COMMENT FOR CHSRA BUSINESS PLAN:

ADDITIONAL UTILITY RELOCATION COSTS ARE MISSING FROM THE ESTIMATE.

ATTACHMENT 2

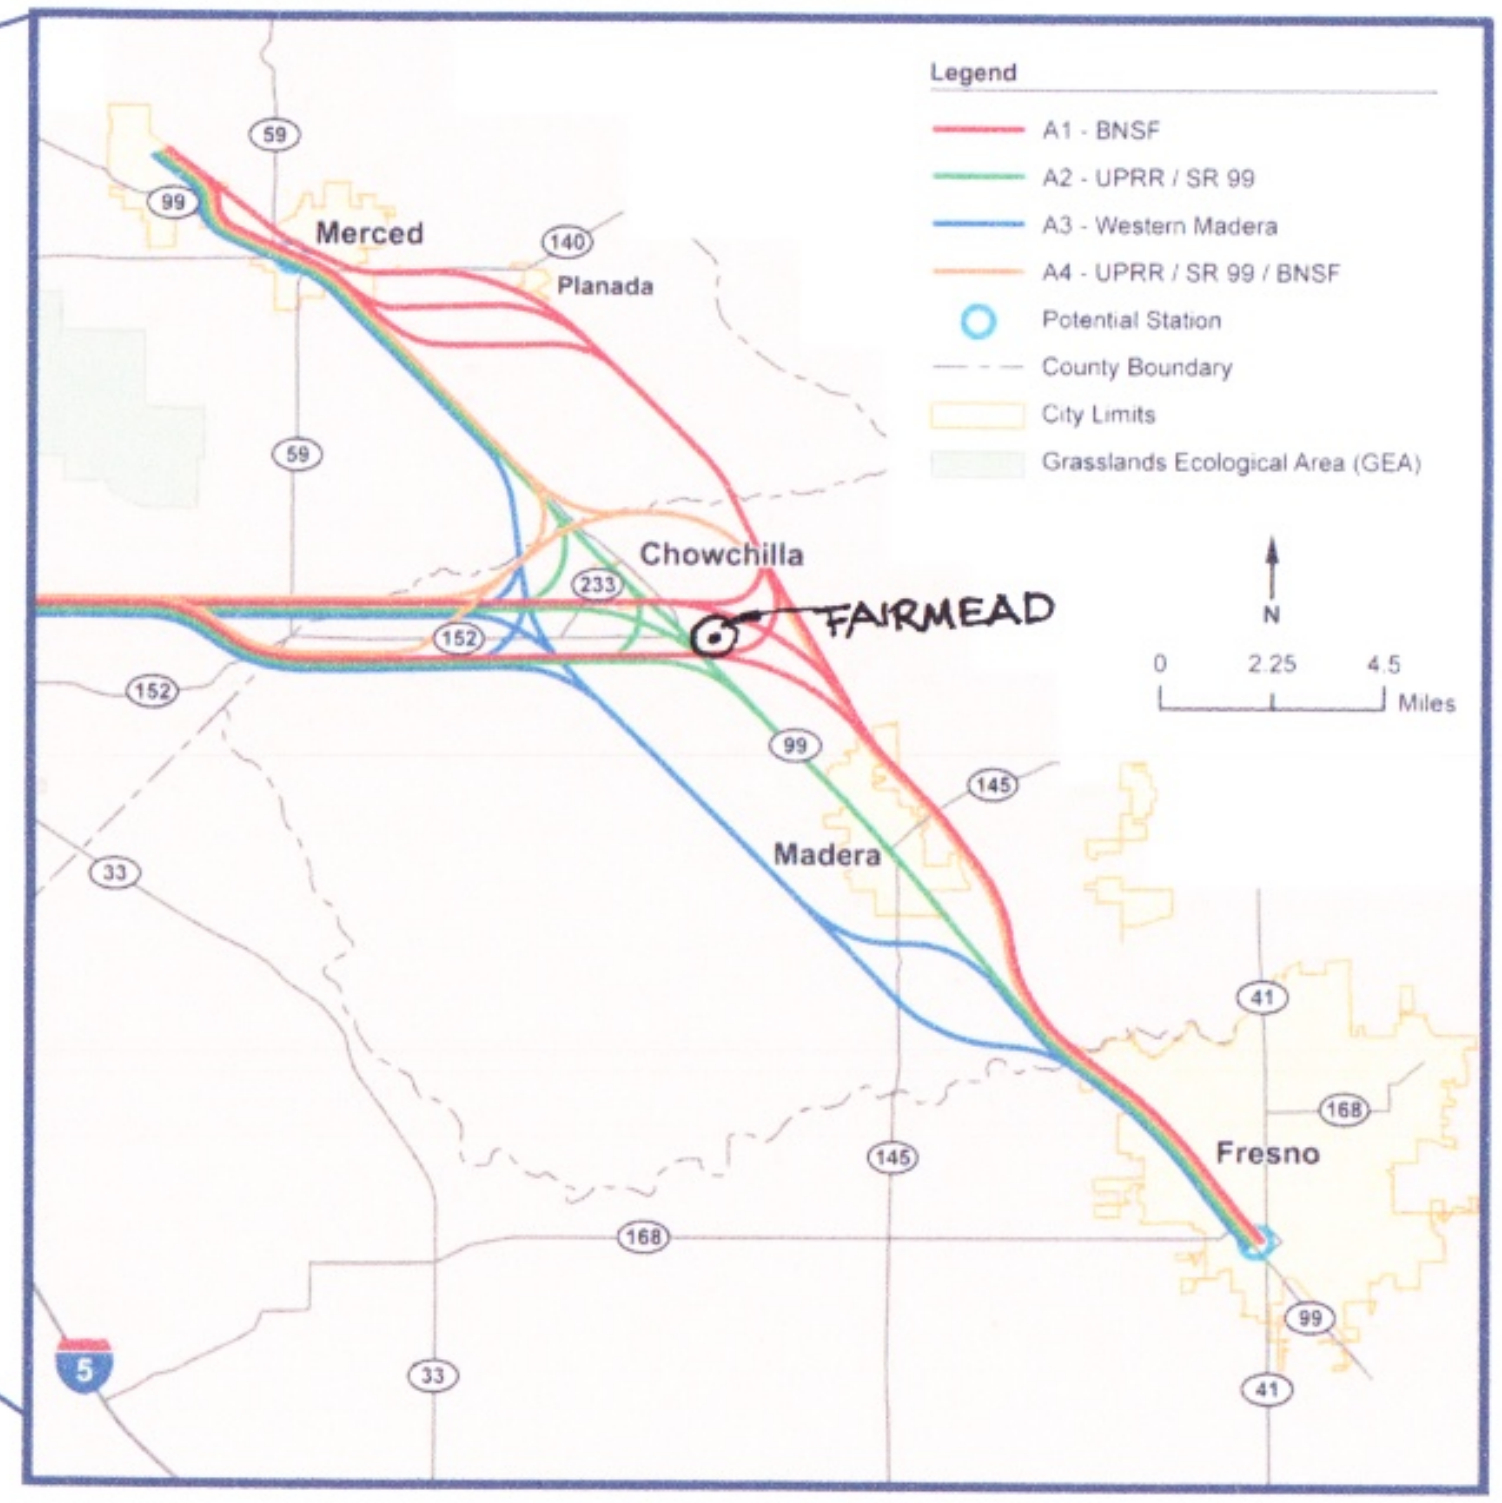
See Attachments 1, 2, and 3, High Speed Rail Maps. The Statewide map has not been updated to show the new curvature between Merced and Fresno.

ATTACHMENT 5B
CHSRA KEY MAP

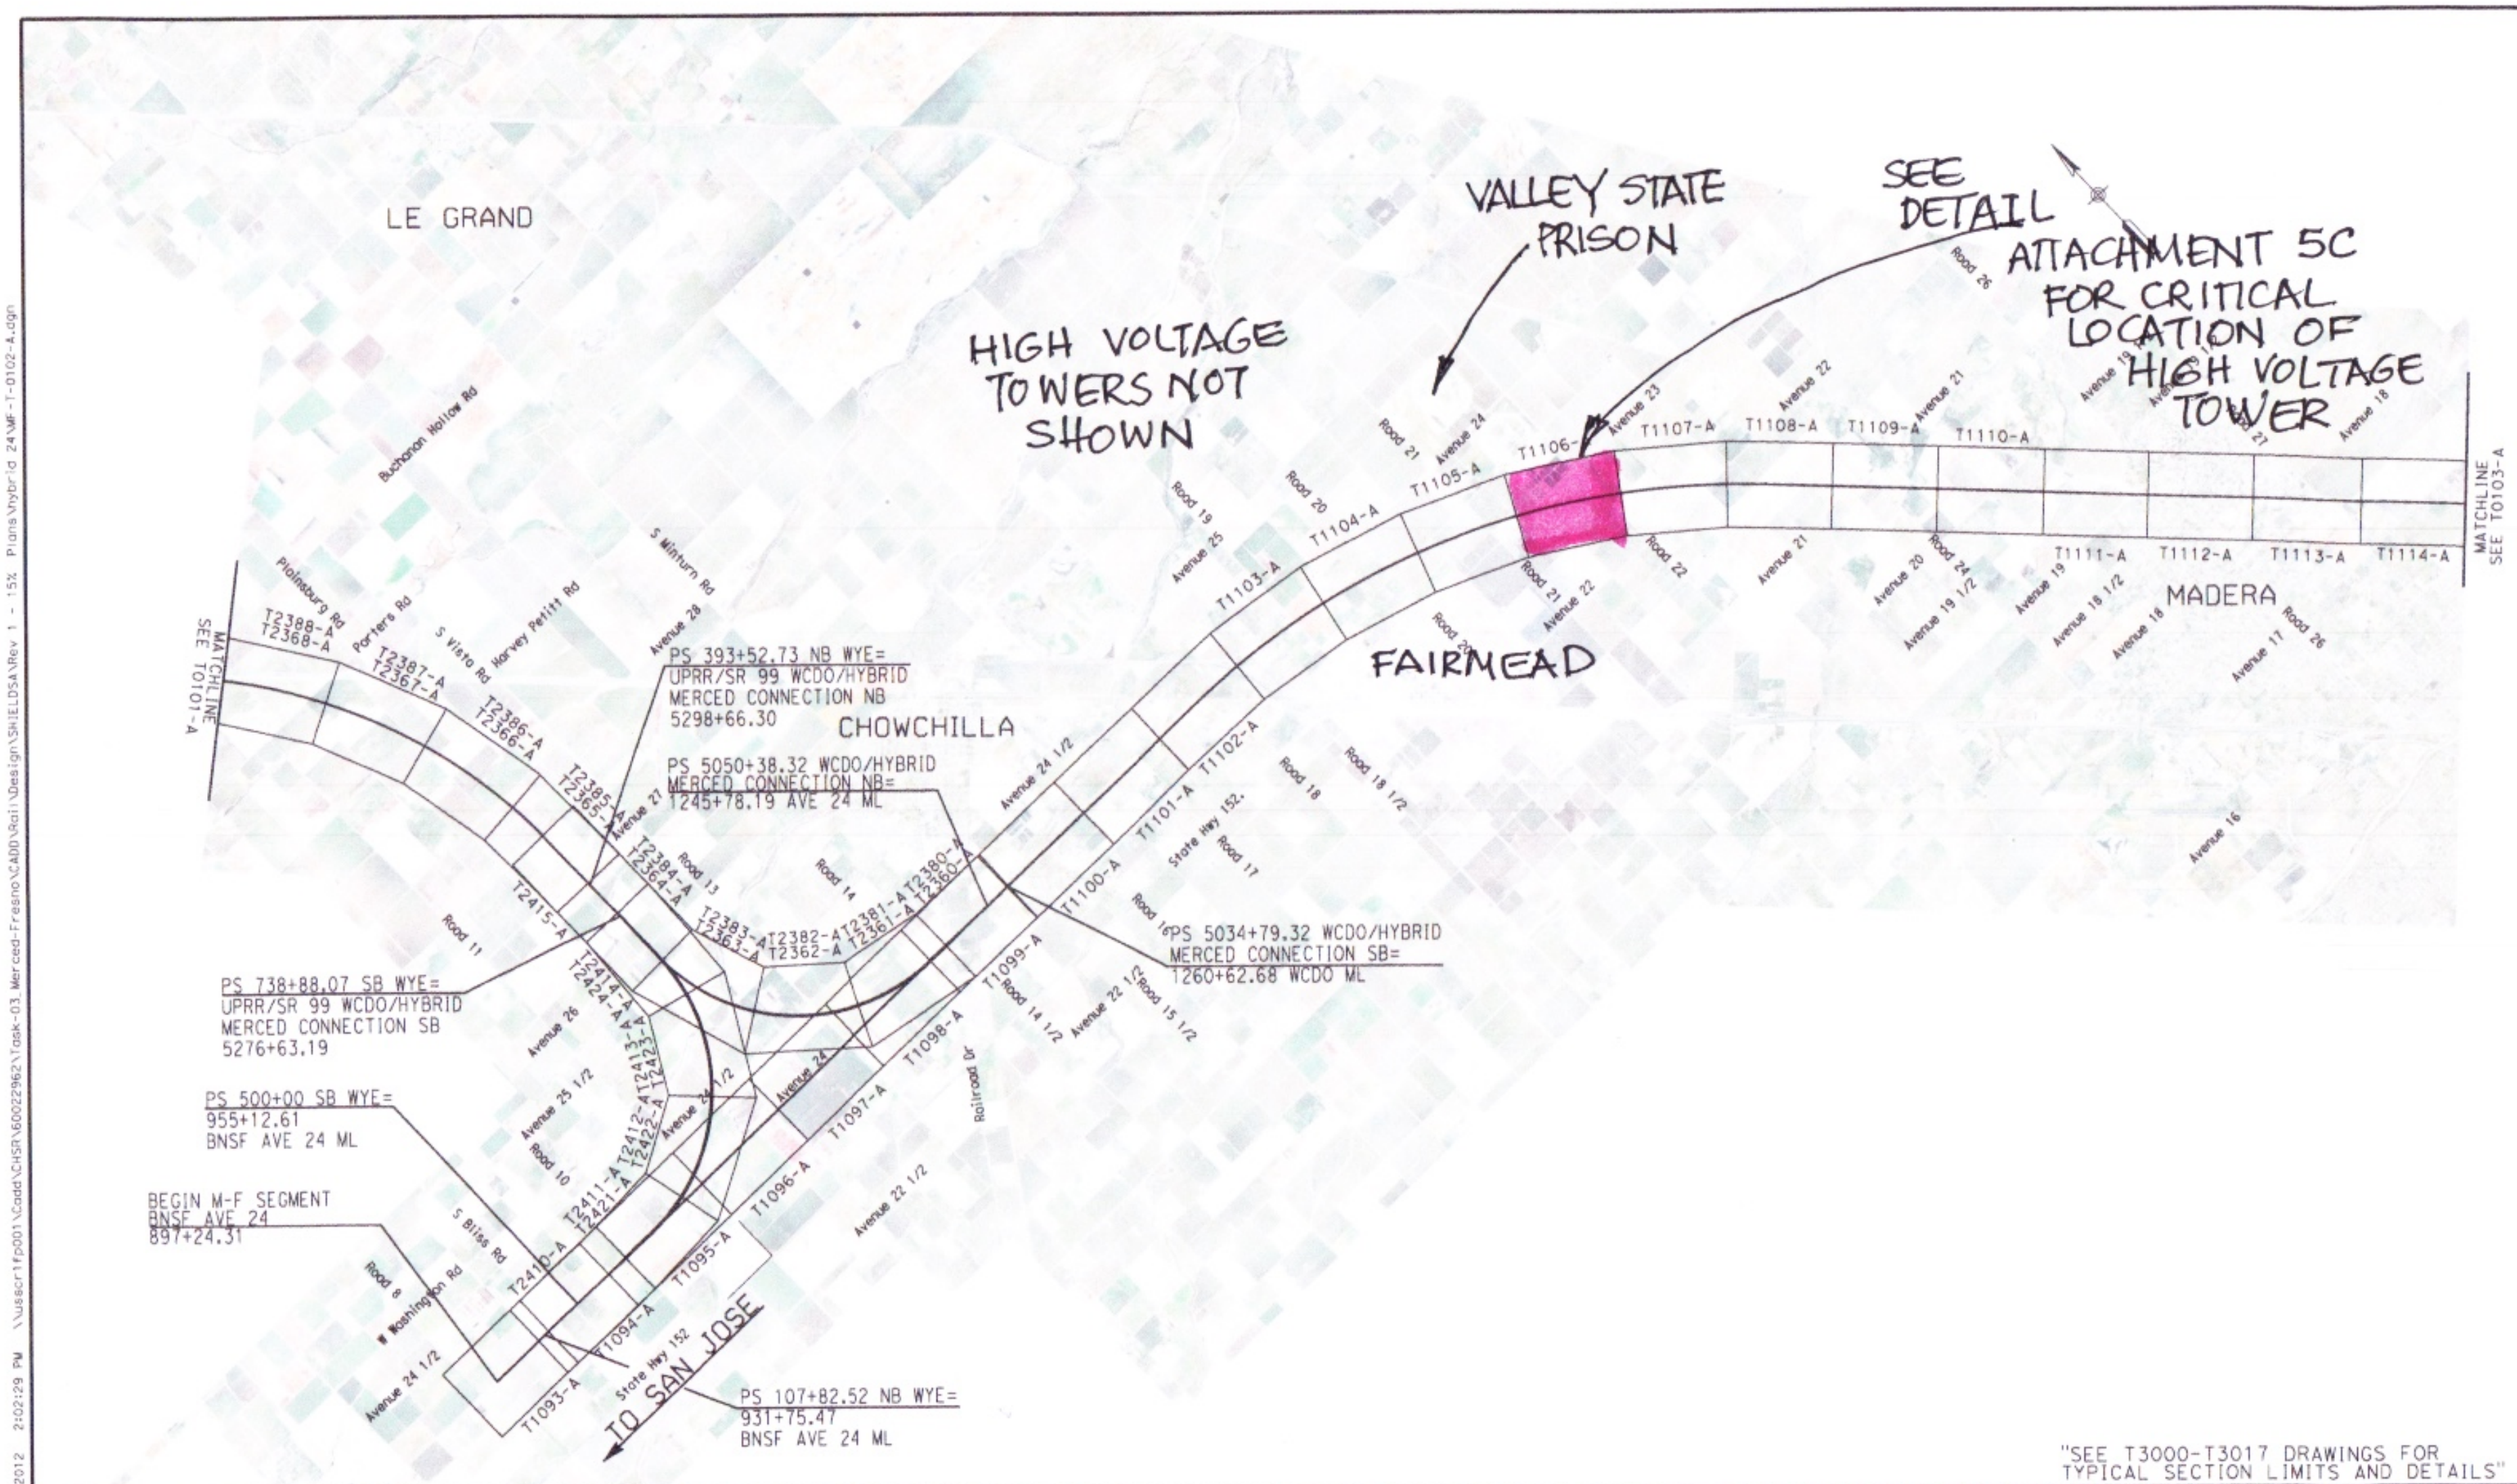
See Attachment 5B, CHSRA Key Map and Attachment 5C, New Tower locations needed to cross HSR tracks. These attachments provide one example of the lack of oversight in the HSR budget.

ATTACHMENT 5C
NEW TOWER LOCATIONS NEEDED
TO CROSS ABOVE HSR CATENARIES

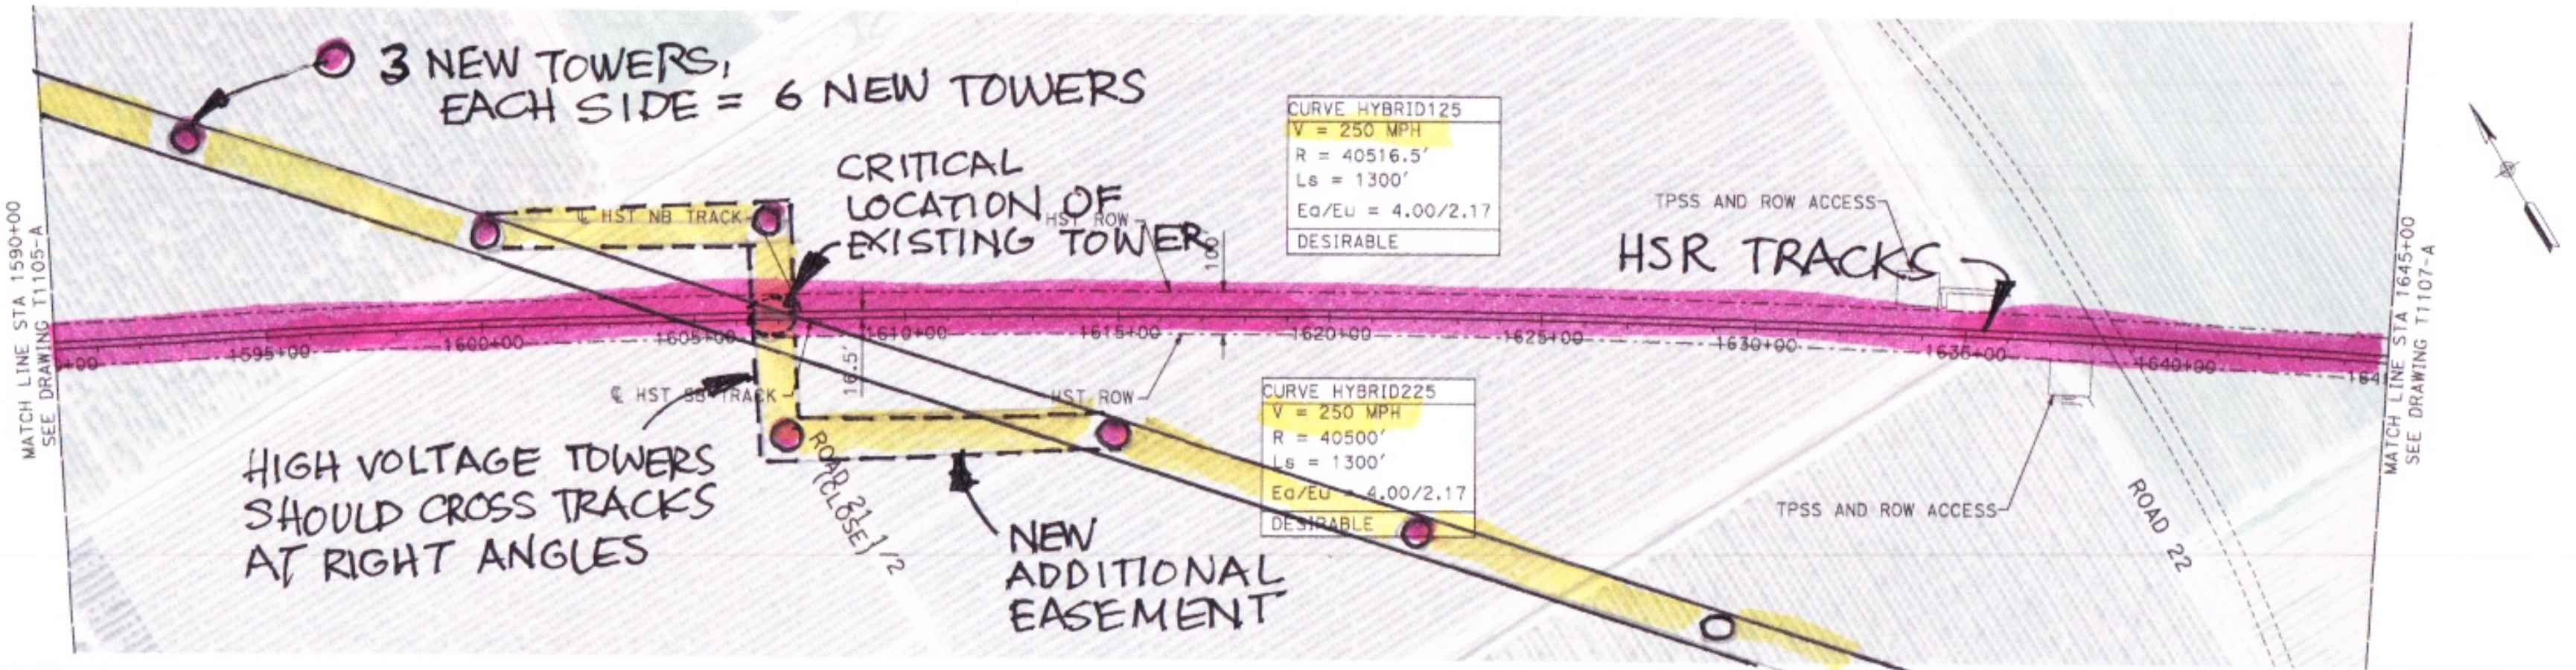
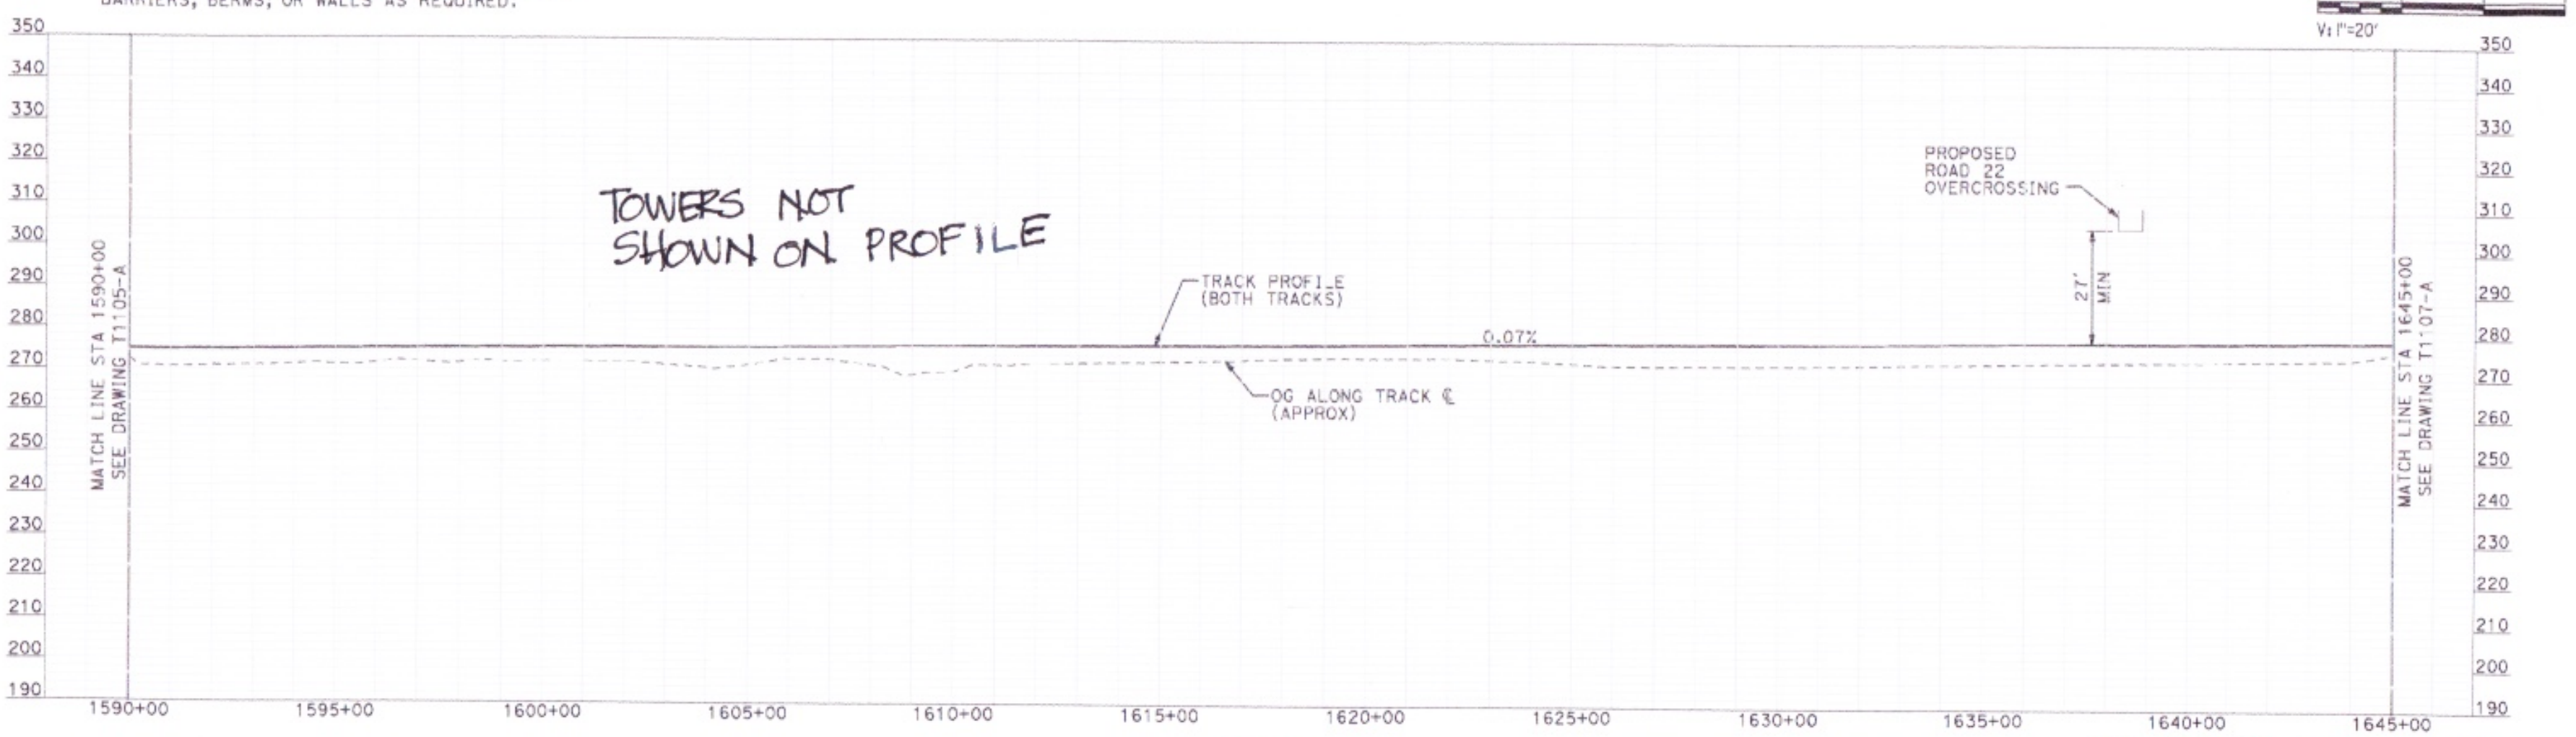
In order to raise the lowest line of an high voltage tower, all the lines on the tower must be raised incrementally. There is a cascading affect and the high voltage towers on either side of the HSR tracks will have to be re-built, approximately three towers on each side of the HSR tracks (See again Attachment 5C for locations of new towers).
